**RE: S38 Road Traffic Act 1994,
Fiddown Village Improvement Scheme 2023**

DATE: 11th October 2023

FIDDOWN VILLAGE IMPROVEMENTS WORKS 2023

Proposed Layout - (Sheet 2 of 2)

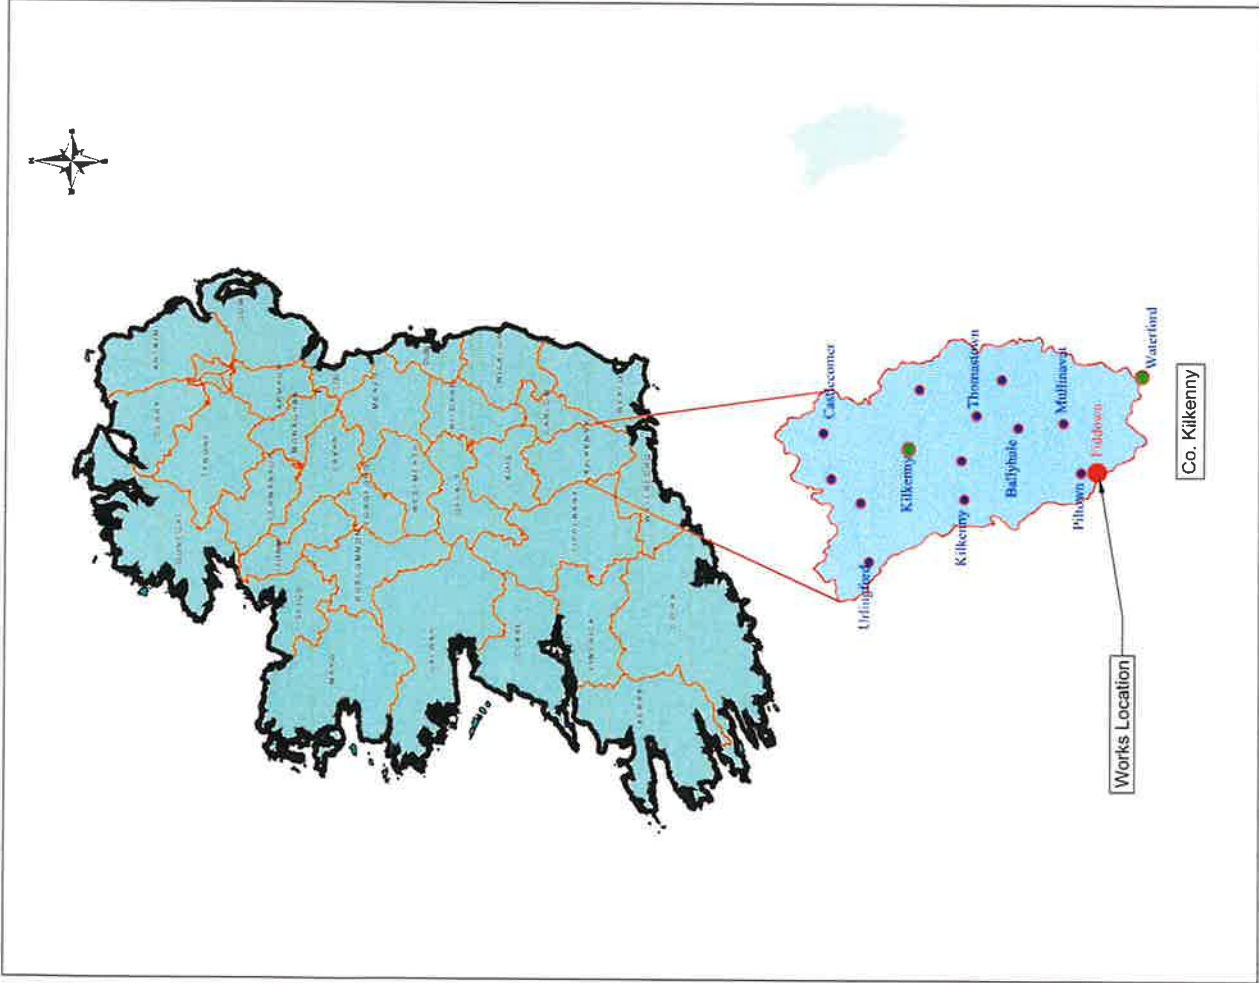
Seeking clarification relating to construction of footpath in the vicinity of Meade's Pub and any connection between the footpaths and the existing pub structure.

Concern raised relating to impact of proposed scheme on building structure where the footpath is connected or where road levels are raised in front of the building

I refer to Draft 2 proposed Layout (sheet 2 of 2) of the above proposed works for Fiddown, Co. Kilkenny and request further information in relation to the proposed footpath to be laid outside my business premises and my home, The Toll Bridge Tavern, more commonly known as Meade's.

As Stan Cullen is aware, the level of the existing road has already impacted negatively on my premises and I would like confirmation if the proposed footpath will be buttressed directly against my property, which is roadside. If this is the case, then I object, in principle, to the footpath being laid outside my premises, as another layer of tarmac/concrete would exacerbate an already existing problem.

I attach a copy of the report on a conservation survey undertaken on my property by ACP, and would draw your attention to pages 30 and 31 where it has been confirmed that the current level of the road is already too high. Adding any further height to the existing road surface would damage my protected structure even further.

The proposed arrangement in the vicinity of Meade's Pub will not involve any buttressing against the building structure at that location and the pavement immediately in front of the property will not be modified.

Footpaths will be provided as part of the junction tightening with level differences limited in places to facilitate short duration vehicular access to the property as well as access for pedestrians at crossing locations.

New gullies will be provided at low points in the area where existing surface water flow lines are modified by the introduction of footpaths.

In addition, where paving is to be modified, a channel will be formed between the paving and the building at the edge of the paving to collect runoff from the pavement and footpath where necessary. This channel will outfall into gullies which will connect with the closed drainage network.
